**CITY OF BATON ROUGE
PARISH OF EAST BATON ROUGE
DEPARTMENT OF PUBLIC WORKS
SEWER ENGINEERING DIVISION**

ADDENDUM NO. 1

SUBJECT: **LA HWY 964 FORCE MAIN REMOVAL PROJECT
CITY-PARISH PROJECT NO. 00-WWI-05A**

1 DITCH SLOPE STABILITY TREATMENT DETAIL
SCALE: NTS

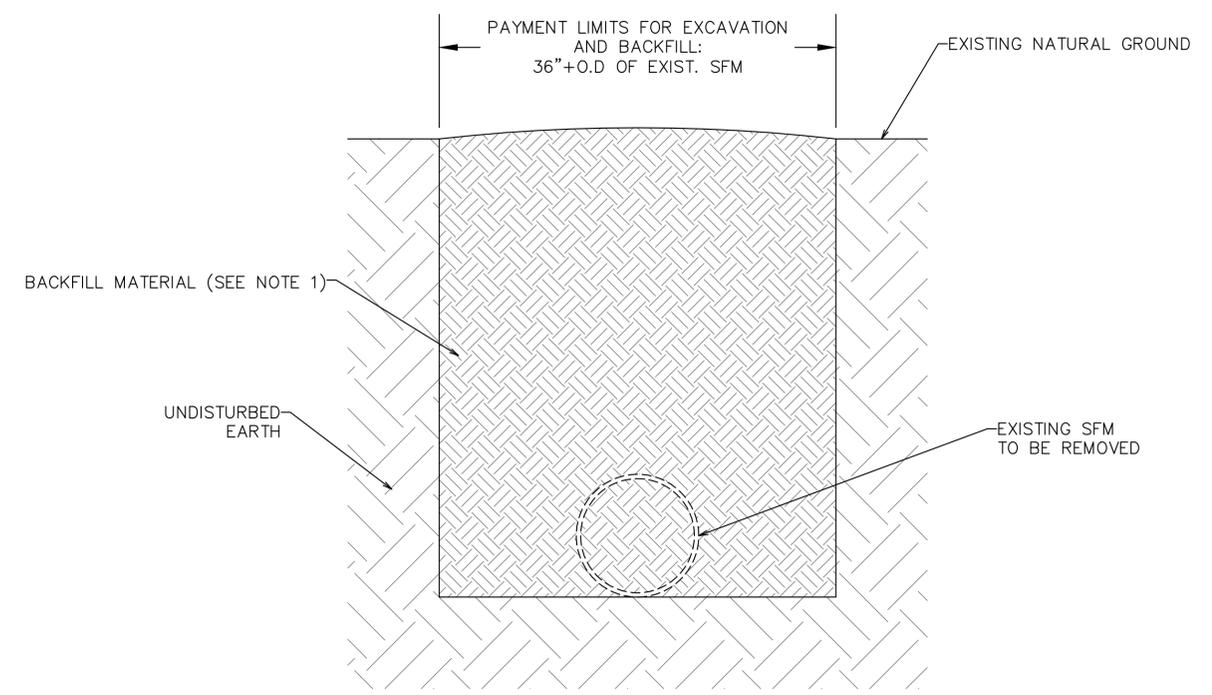
- Sheet G-02: Revised general note # 29 to clarify locations of fittings and appurtenances.
- Sheet G-03: Symbol for addendum added.
- Sheet C-06: Revised as follows:
 - Detail No. 1: Revised drawing call-out to clarify the use of imported clay fill.
 - Note No. 1: Revised the sheet note to clarify use of imported clay fill for backfill of restrained joint pipe and/or connections.
 - Note No. 3: Revised the sheet note to clarify use of imported clay fill for backfill of pipe removal trenches in ditch slopes.

- SHEET NOTES
- FOR SEGMENTS REQUIRING REMOVAL OF EXIST. SFM, USABLE EXCAVATED SOILS SHALL BE USED AS BACKFILL MATERIAL. USABLE SOILS SHALL CONFORM TO SECTION 801-3-A-2 OF THE SPECIFICATIONS. FOR SEGMENTS EXCAVATED TO PROVIDE RESTRAINED JOINTS IN THE EXISTING SFM, BACKFILL MATERIAL SHALL BE IMPORTED CLAY FILL. IMPORTED CLAY FILL SHALL CONFORM TO SECTION 801-3-A-5 OF THE SPECIFICATIONS.

- IMPORTED CLAY FILL TO BE COMPACTED USING 8" LOOSE LIFTS. IMPORTED CLAY FILL SHALL MEET THE REQUIREMENTS MENTIONED IN NOTE 1 ABOVE. THE COST OF IMPORTING, PLACING, AND COMPACTING THE IMPORTED CLAY FILL SHALL BE INCLUDED IN THE PRICE PER CUBIC YARD FOR IMPORTED CLAY FILL.
